Access Compliance Report

Public Rights-of-Way

(Curb Ramps)

Intersection ID: 10042371	Main Street: WYALONG_DR	Cross Street: N/A	Location: E
ADA ID: 05058971A700	Ramp Type: Perp	Initial Pass/Fail: Fail	Overall Compliance: No
Severity Score: 1.25			
Codes/Mitigation Info/Possible Solution		Field Measurements/Component Compliance

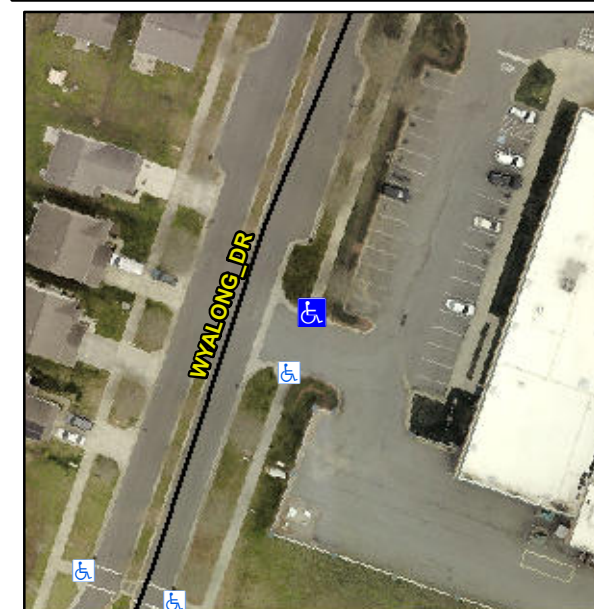
R304.5.3

Compliance	Description	Data	Compliance	Description	Data
N/A	Ramp Length (in)	96.0	Yes	Ramp Slope (%)	5.5
Yes	Ramp Width (in)	70.5	No	Ramp XSlope (%)	2.2
N/A	Flare Type LT	N/A	N/A	Flare Type RT	N/A
N/A	Flare Slope LT (%)	N/A	N/A	Flare Slope RT (%)	N/A
N/A	Flare Traversable LT?	N/A	N/A	Flare Traversable RT?	N/A
N/A	Landing Length (in)	N/A	N/A	DWS Provided?	N/A
N/A	Landing Width (in)	N/A	N/A	DWS Contrast?	N/A
N/A	Landing Slope (%)	N/A	N/A	DWS Length (in)	N/A
N/A	Landing X Slope (%)	N/A	N/A	DWS Full Width?	N/A
N/A	Landing Curb? (Y/N)	N/A	N/A	DWS Offset (in)	N/A
N/A	Shared Landing?	N/A			
N/A	Gutter Ponding?	N/A	N/A	Gutter Slope (%)	N/A
N/A	Gutter Lip Ht (in)	N/A	N/A	Gutter X Slope (%)	N/A
N/A	Painted X Walk1?	No	N/A	Painted X Walk2?	N/A
	X Walk 1 Direction	To SW		X Walk 2 Direction	N/A
N/A	X Walk 1 Width (in)	N/A	N/A	X Walk 2 Width (in)	N/A
	X Walk 1 Slope (%)	0.7		X Walk 2 Slope (%)	N/A
	X Walk 1 X Slope (%)	1.4		X Walk 2 X Slope (%)	N/A

Remove & Replace Entire Ramp.
